ADDENDUM NO. 1

RFB#8513 Septage Disposal Site – Paving & Concrete Improvements

This Addendum No. 1 shall be incorporated into and made part of the above referenced contract documents for RFB#8513.

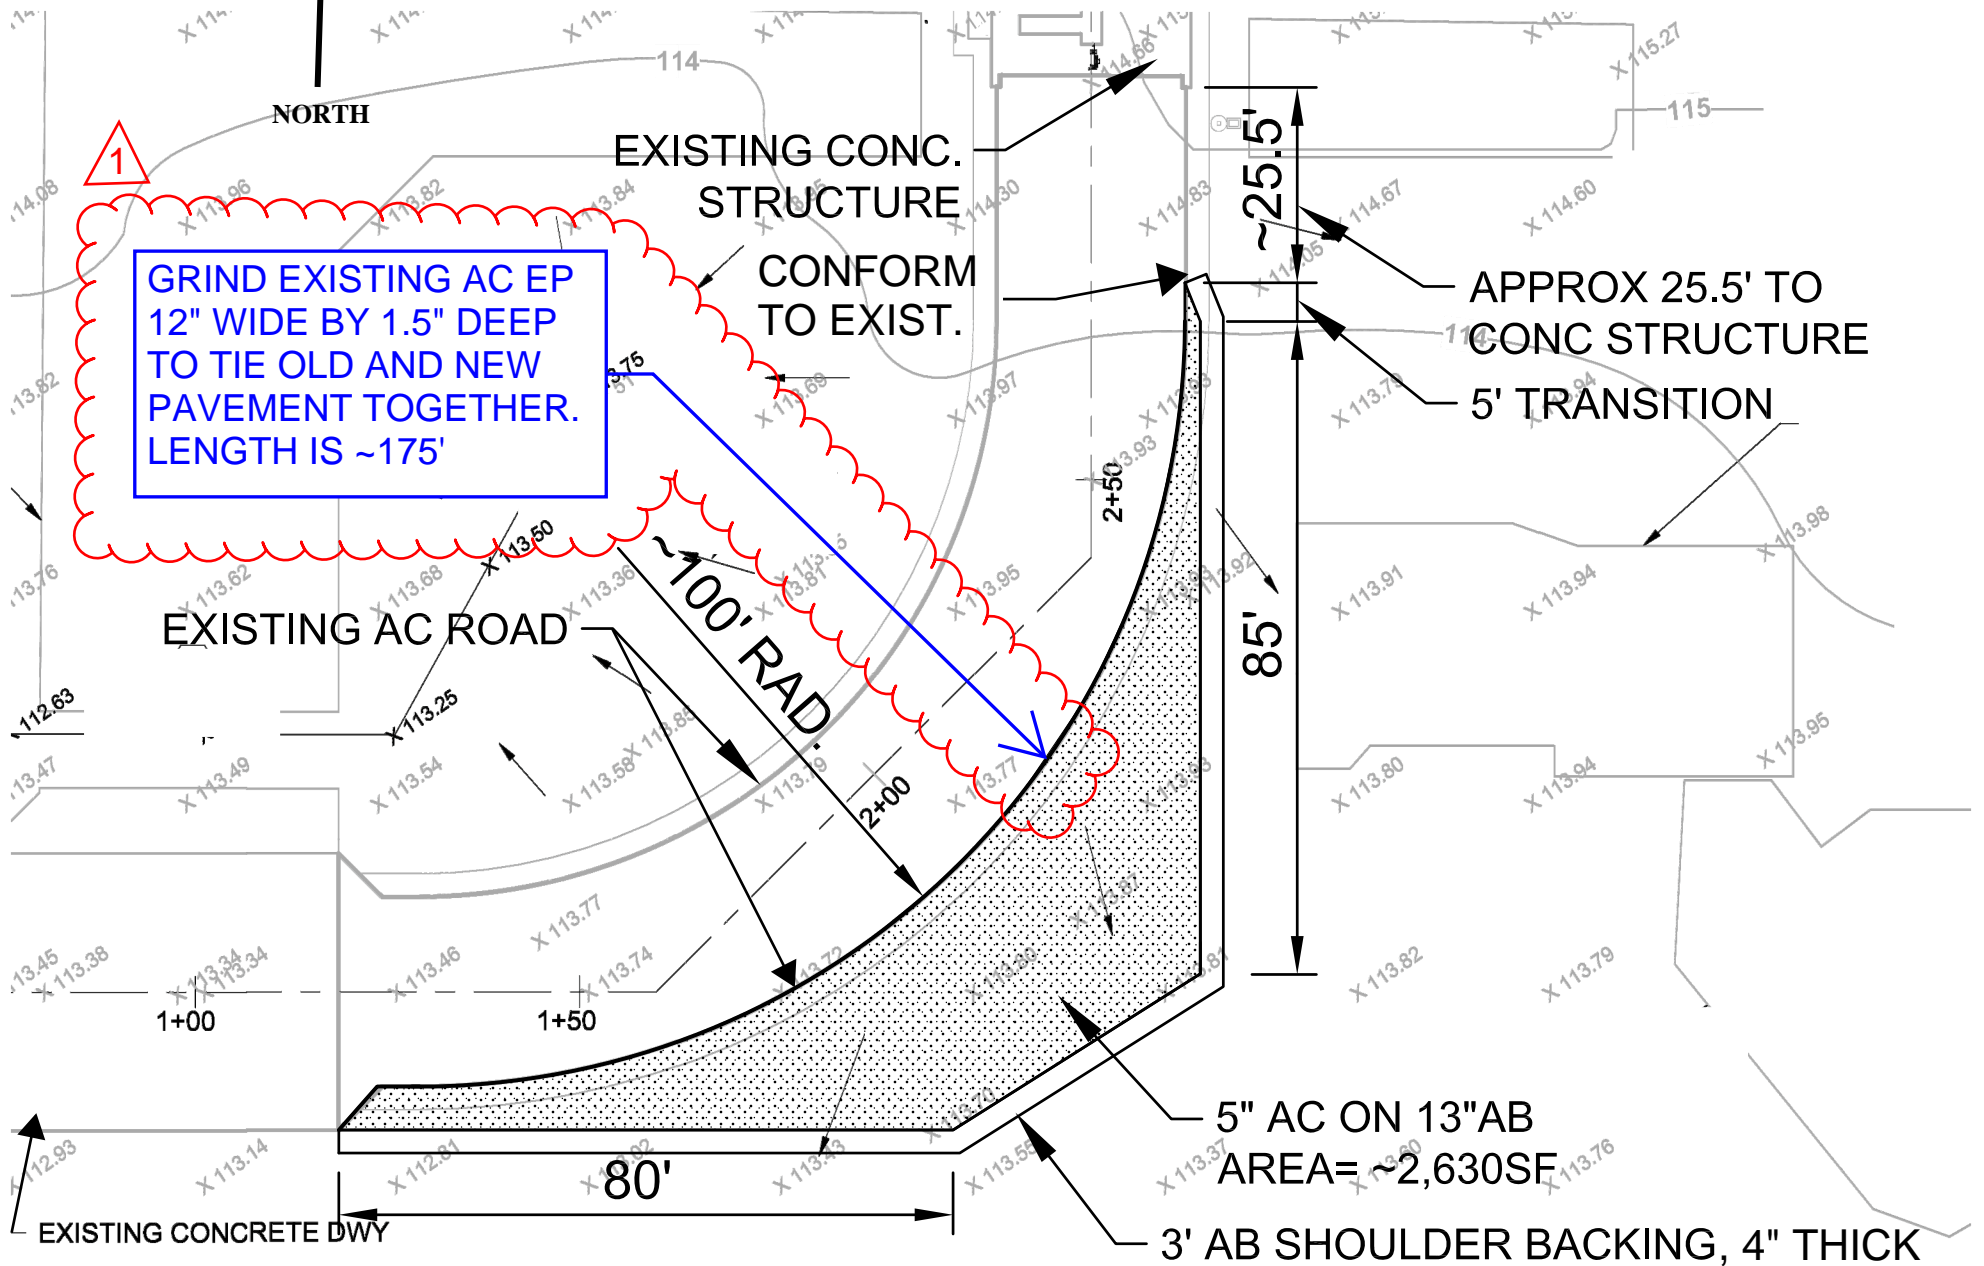
Addendum Item	Section and Page or Drawing No.	Location and Description of Change
1.01	Volume 2 - Drawings Page 2 & 3	See clouded revisions on pages 2 & 3: ADDS 12” wide by 1.5” depth pavement grind to existing pavement edge.
1.02	Volume 2 - Drawings Page 4	See clouded revision on page 4: Revises the “SAWCUT AC...” note to clarify the objective.

GRIND EXISTING AC EP
12" WIDE BY 1.5" DEEP TO
TIE OLD AND NEW
PAVEMENT TOGETHER.
LENGTH IS ~175'

AC PAVING PLAN VIEW

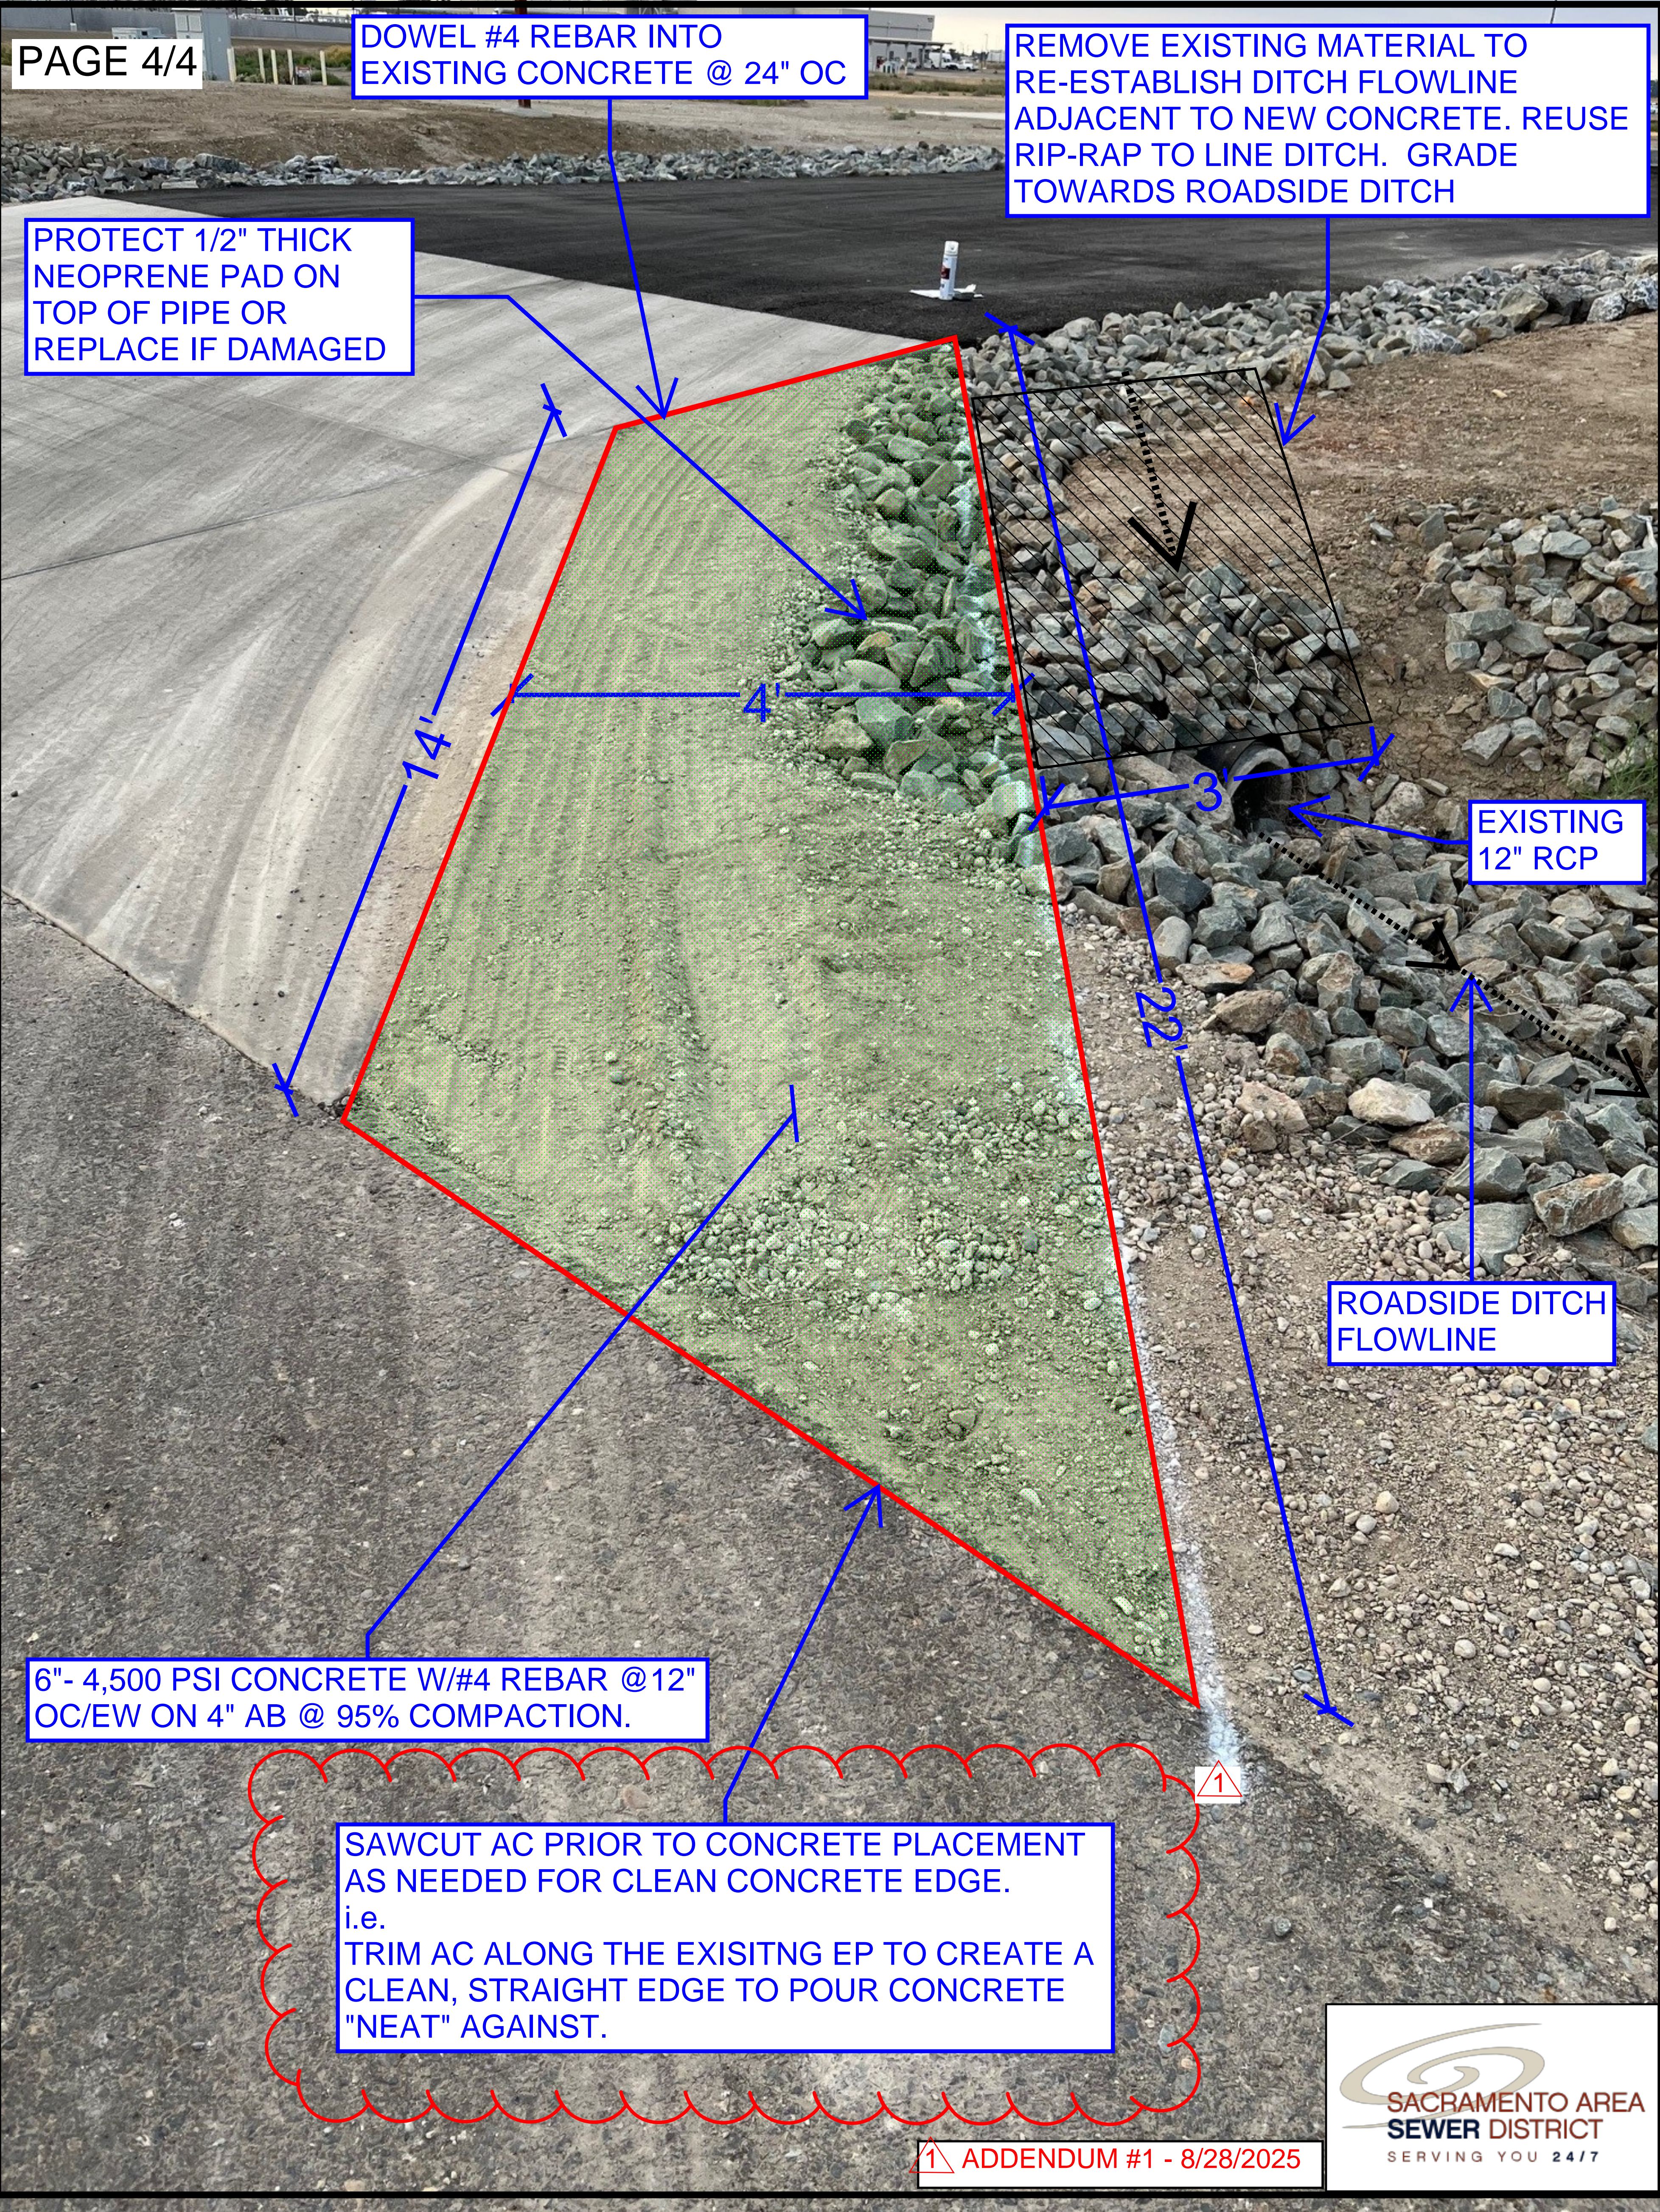
SAWCUT AC PRIOR TO CONCRETE PLACEMENT AS NEEDED FOR CLEAN CONCRETE EDGE. i.e. TRIM AC ALONG THE EXISITNG EP TO CREATE A CLEAN, STRAIGHT EDGE TO POUR CONCRETE "NEAT" AGAINST.
